Access Compliance Report

Public Rights-of-Way

(Curb Ramps)

Intersection ID: 28094	Main Street: MITCHELL_GLEN_DR	Cross Street: SCOTTISH_KILT_CT	Location: SW
ADA ID: 72FF612F50EB	Ramp Type: BlendTrans1	Initial Pass/Fail: Fail	Overall Compliance: No
Severity Score: 21.25			
Codes/Mitigation Info/Possible Solution		Field Measurements/Component Compliance

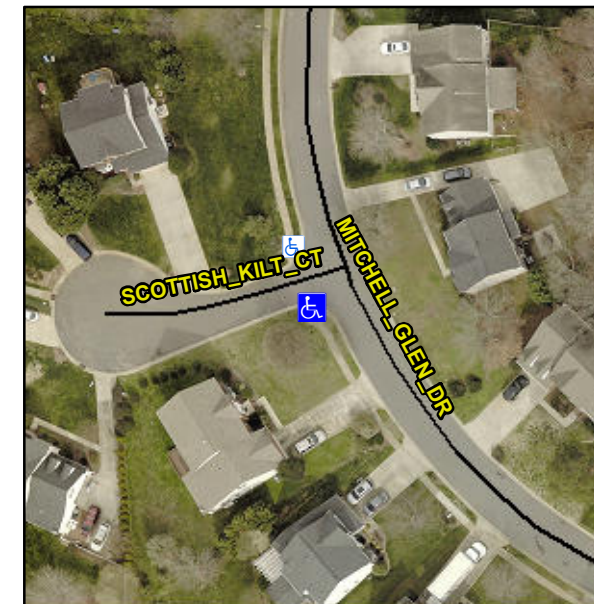
Remove & Replace Curb Ramp With Two New Directional Ramps or Equivalent.

R304.5.1, R304.5.3
